UNITED STATES PATENT AND TRADEMARK OFFICE

10/576,197

Toshi Watanabe

Office Action Summary	Application No. 10/576,197	Applicant(s) WATANABE, TOSHI	
	Examiner Kristen C. Hayes	Art Unit 3643

Modified Figure 1, US 5,666,904

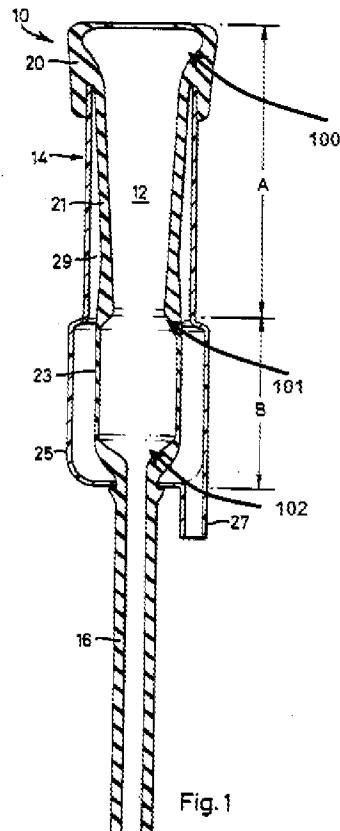
9. Regarding claim 1, Grindal discloses a teat cup for laboratory animals wherein one side of the teat cup is attached to the udder of a laboratory animal (Grindal, abstract), through suction and the other side of said teat cup is connected to a negative-pressure generating source via a milk collecting container (Grindal, column 1: line 18) with said teat cup comprising a first conical portion (100), a second conical portion (21) continuous from the first conical portion, a third conical portion (101) continuous from the second conical portion, a cylindrical teat holding portion (23) continuous from the third conical portion and a connecting portion (16) which is connected (as best understood) on the side of the negative-pressure generating

source, wherein the second conical portion, the third conical portion, and the teat holding portion are dimensioned slightly larger than the actual sizes of the conically bulging portion of the udder, said teat base portion, and the teat of the laboratory animal to be milked.

10. Regarding claim 2, Grindal further discloses the teat holding portion includes a region with an increased cross-sectional area (as best understood) near where the tip of the teat is to be located (Grindal, Figure 1).

11. Regarding claim 3, Grindal further discloses the teat holding portion comprises a conical surface (102) that becomes narrower toward the tip thereof.
